PLAN COMMISSION MEETING AGENDA

**TUESDAY, March 22, 2016
 AT 6:00 PM**

PROJECT: Plan Review – Drexel Partners, LLC

STAFF RECOMMENDATION: That the Plan Commission approves the site and building plans submitted by Drexel Partners, LLC, for the property at 600 W. Drexel Ave., with the following conditions:

1 ARCHITECTURAL SITE PLAN
 A4.1 X1.3 1" = 20'-0"

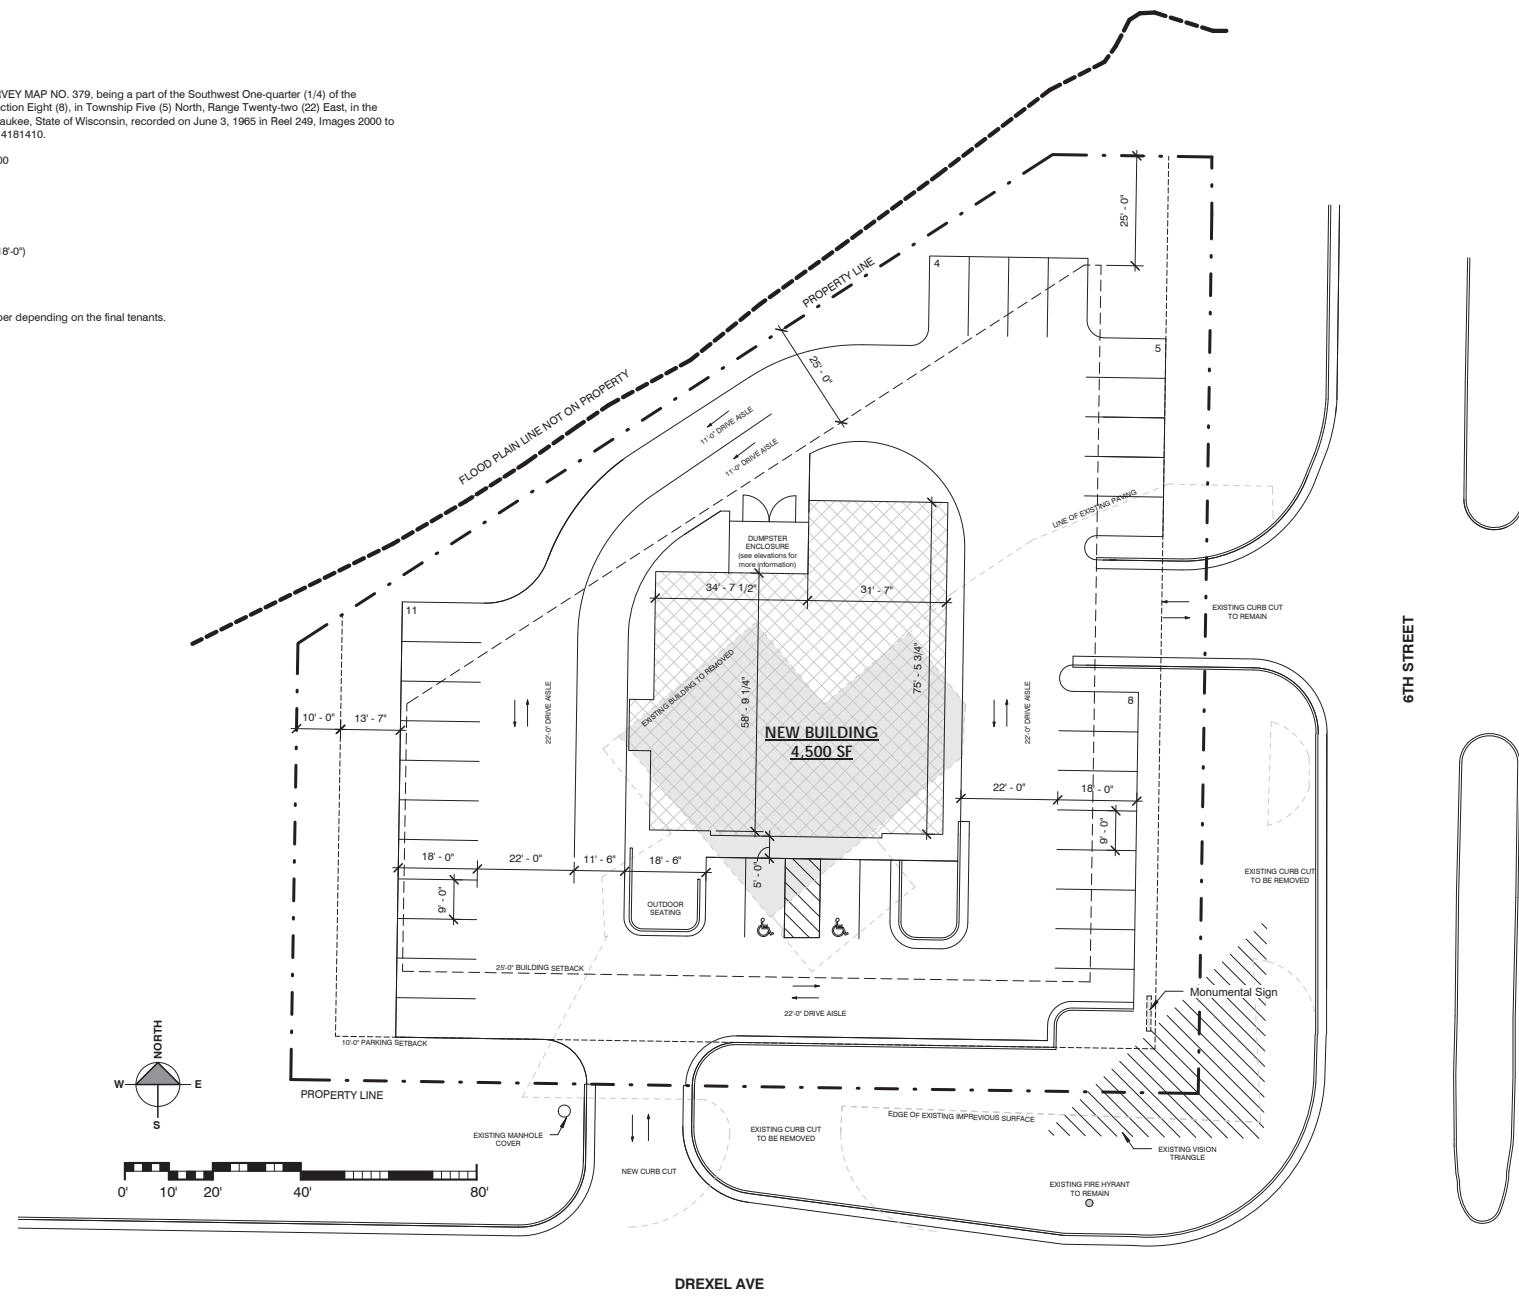
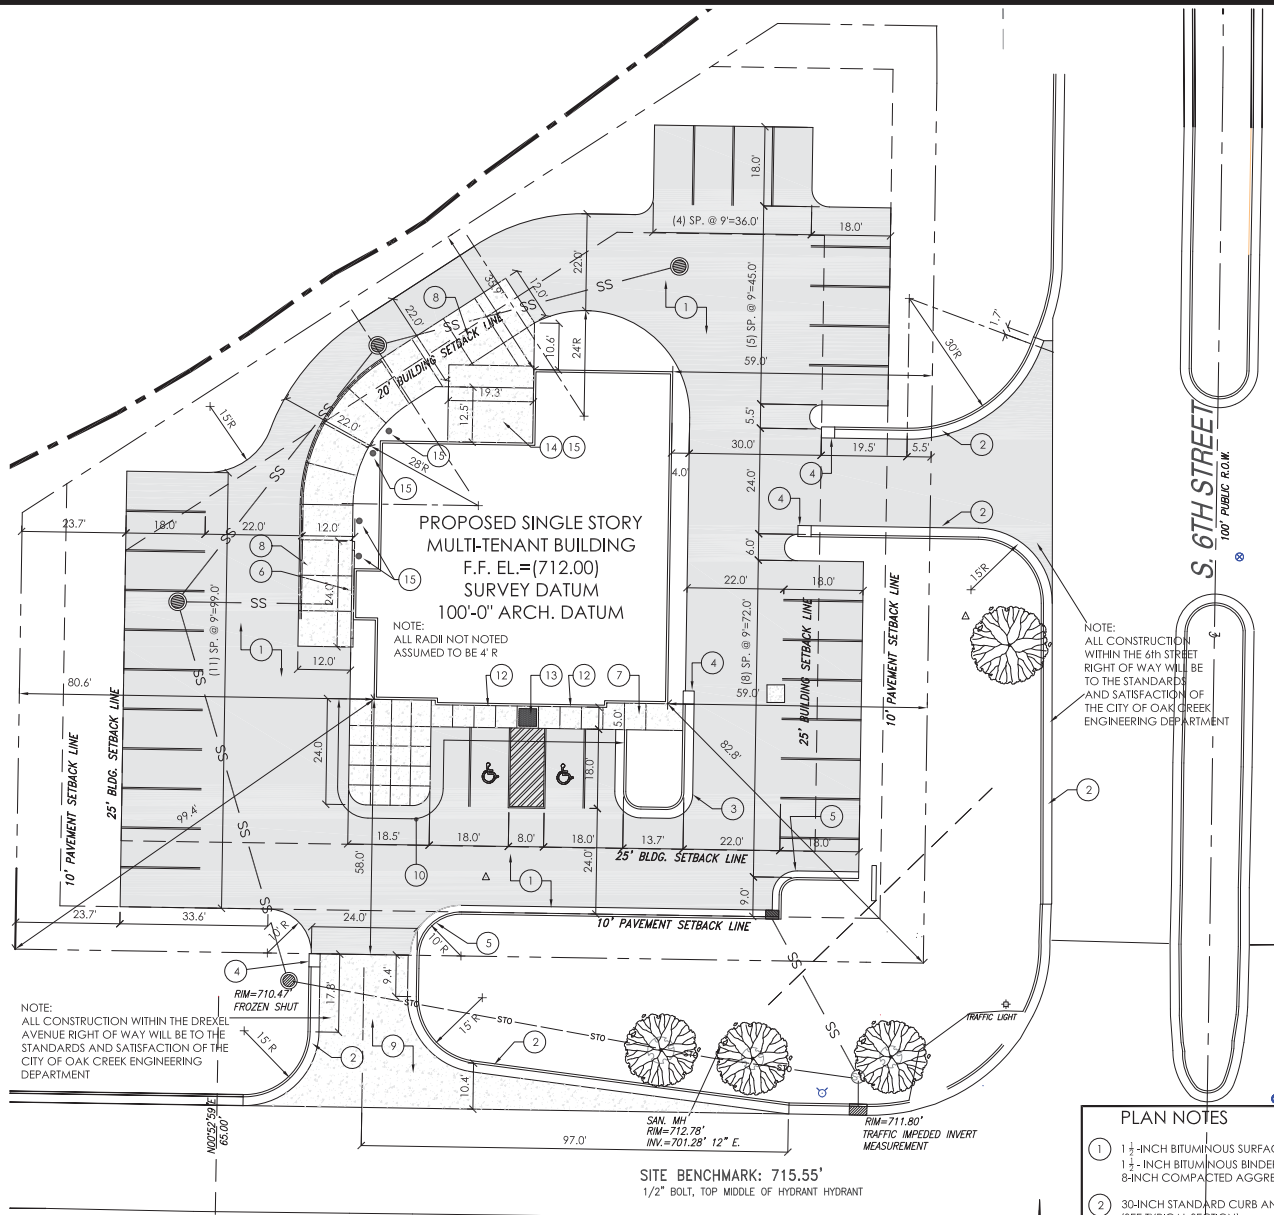
1. That the exterior stone veneer meets the minimum 4-inch thick requirement per Code.
2. That the plans are revised to meet the minimum 30% open space requirement (revise calculations).

As proposed, the building and parking meet all setback requirements. In response to staff comments regarding access from Drexel Avenue, the plans have been revised to include a taper into the south driveway (which has also been moved slightly west). One monument sign location has been proposed on

One 19' 8" x 6' 2" dumpster enclosure is proposed on the north side of the proposed building, which will be partially screened by the building itself (east tenant space). The west enclosure wall and gates are proposed to be constructed with lap siding to match the building, shown as wood plank similar to the wood panels on the elevations. Staff notes that the labels on the exterior elevations and Sheet C2.3 do not match, and should be corrected prior to submission of revised plans.

Calculations for impervious and open space are included on the plans. There is an error that will be corrected to ensure that the required minimum 30% open space is maintained. This is included as a condition of approval above.

1 PROPOSED MASTER LANDSCAPE PLAN

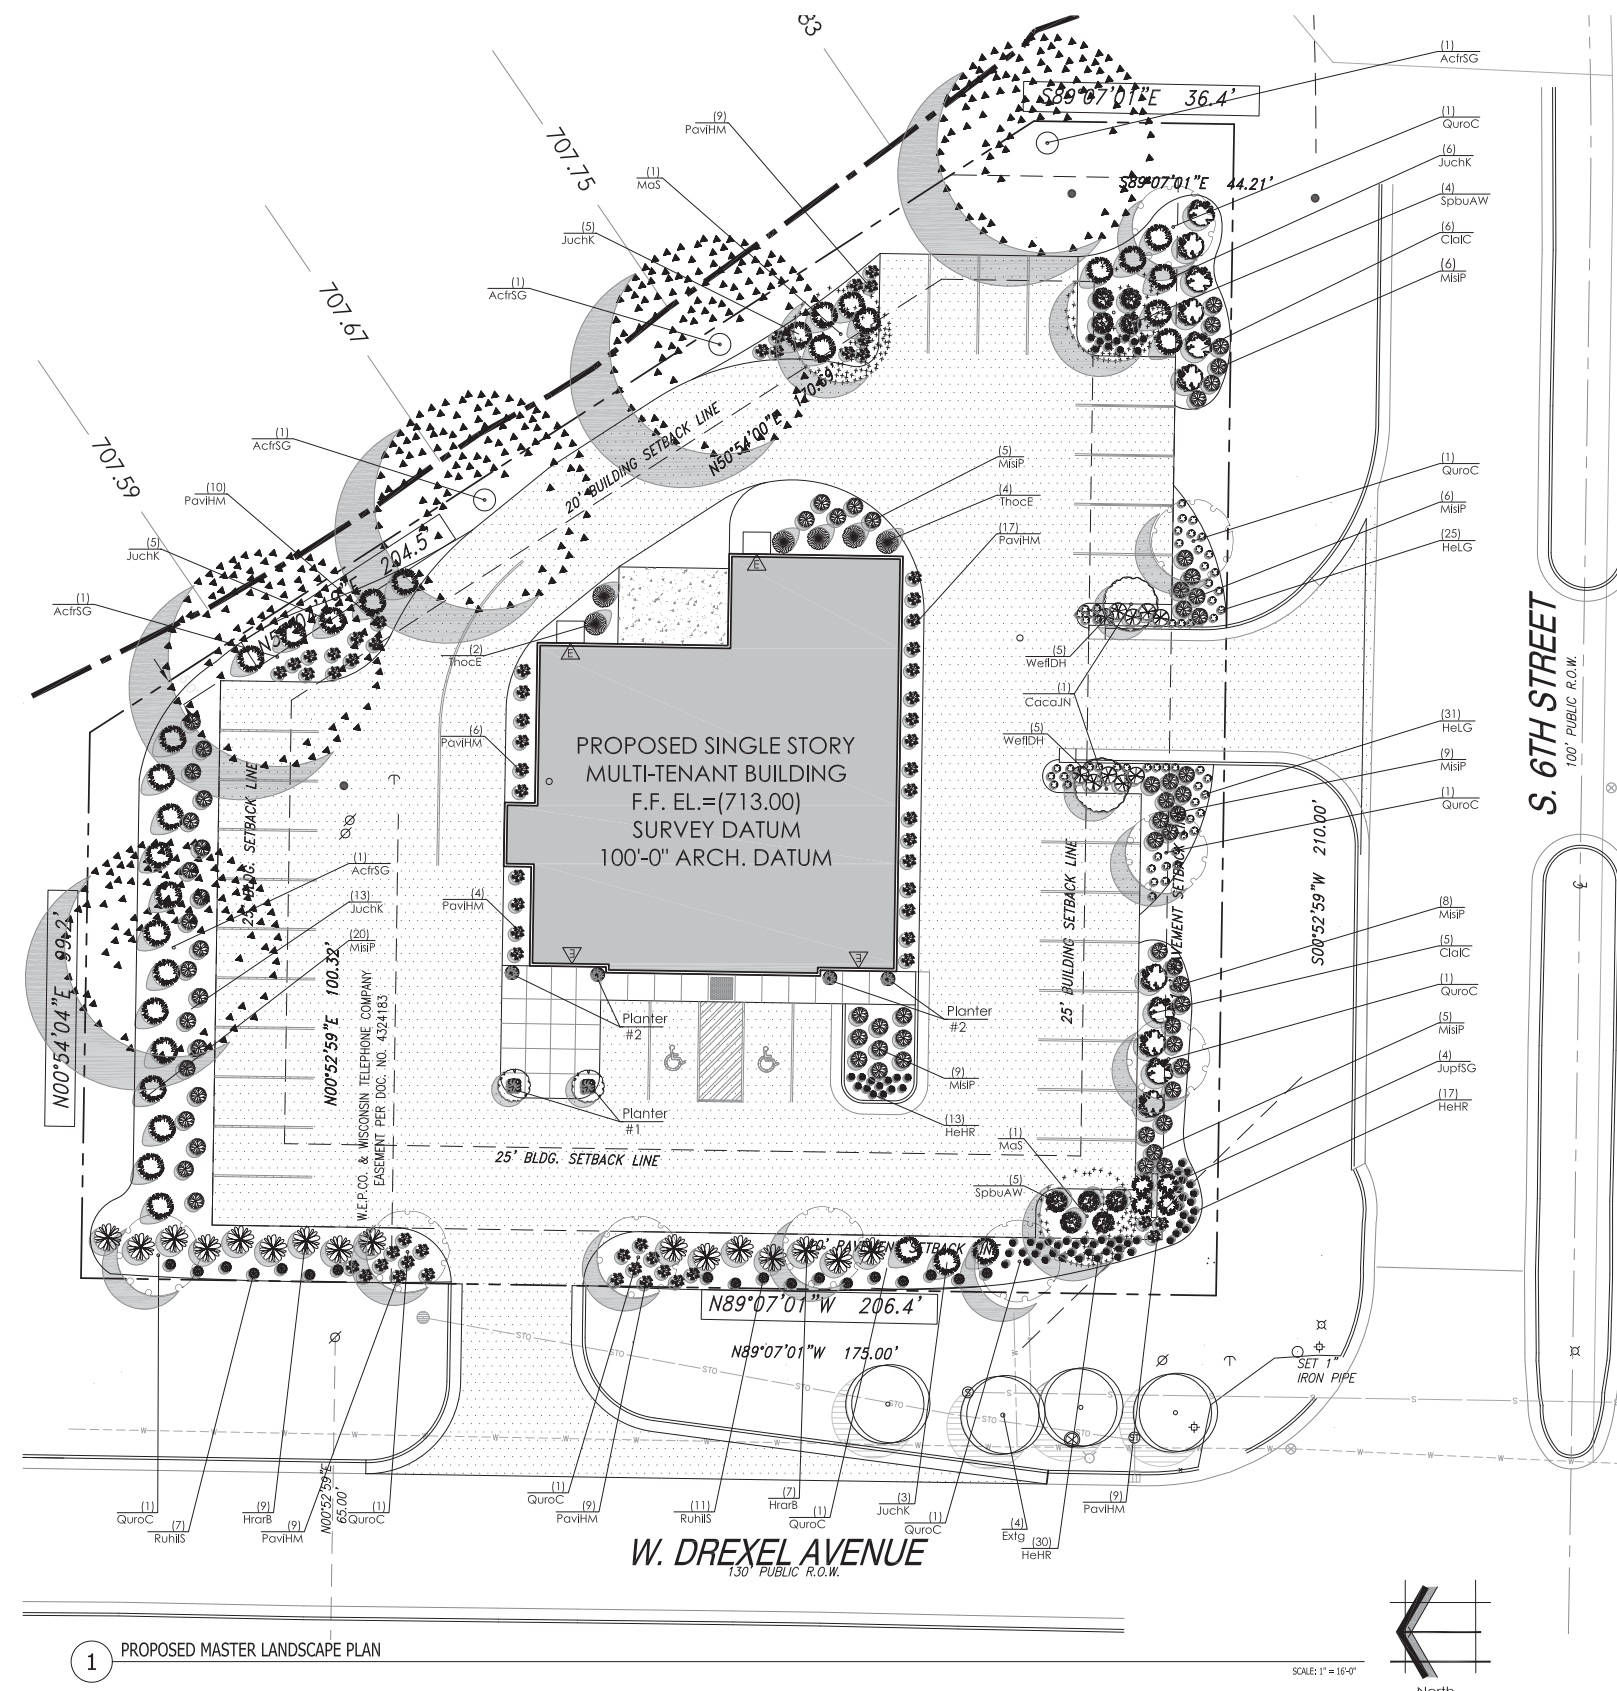
Landscaping plans have been submitted and reviewed by the City Forester. Minor revisions may be required, and staff continues to work with the applicant on the plans. A condition of approval recommends that final plans be submitted for review and approval by the Department of Community Development prior to submission of building permit applications.

3. That all revised plans (site, building, landscaping, etc.) are submitted in digital and paper formats for review and approval by the Department of Community Development prior to the submission of building permit applications.

PHO1.1

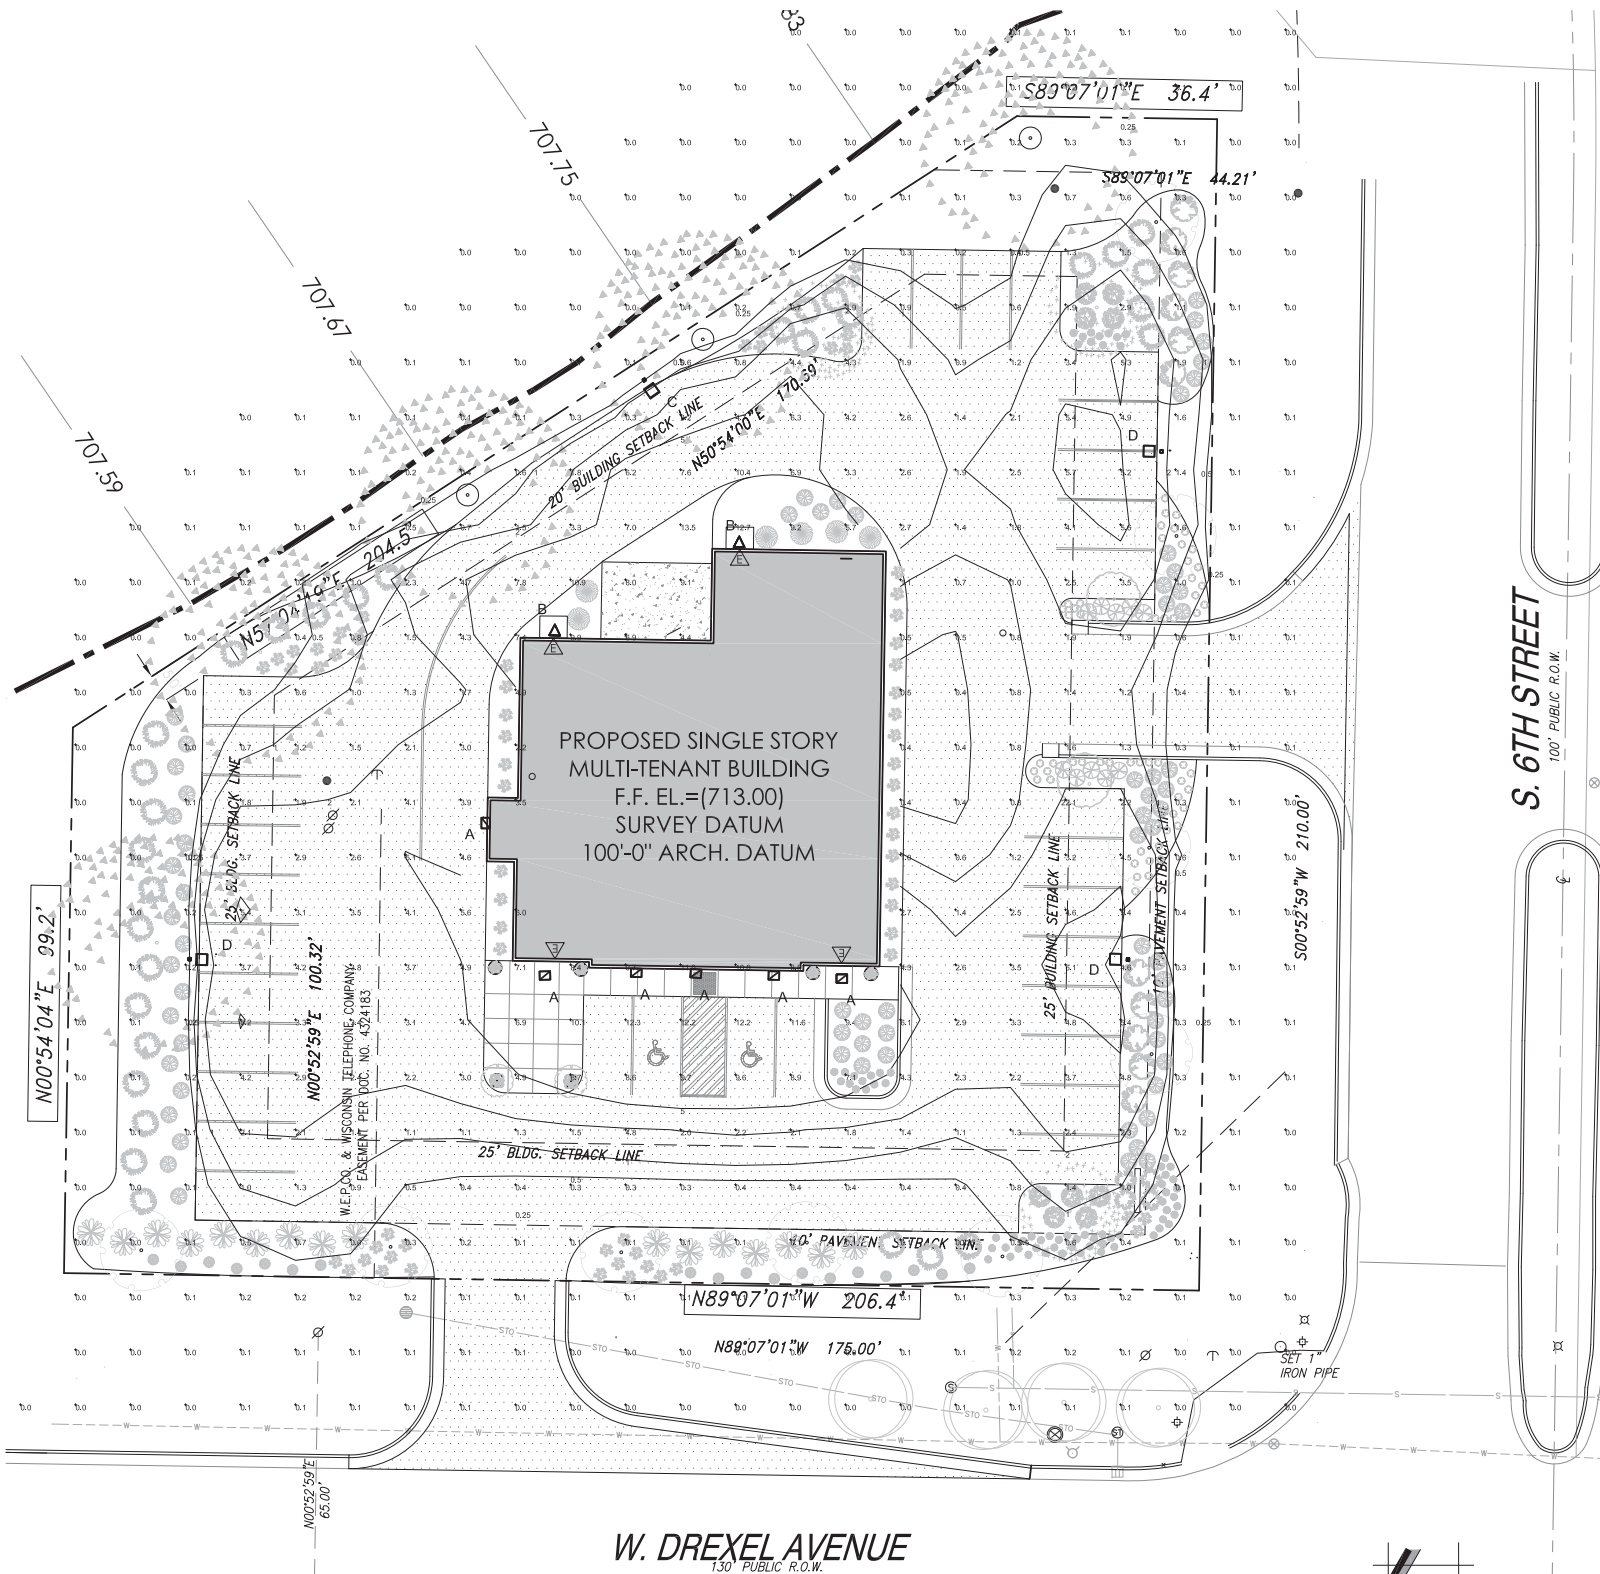
No comments were provided regarding the proposed lighting plan. Final lighting plans must be approved by the Electrical Inspector prior to issuance of permits, as noted in the proposed conditions of approval.
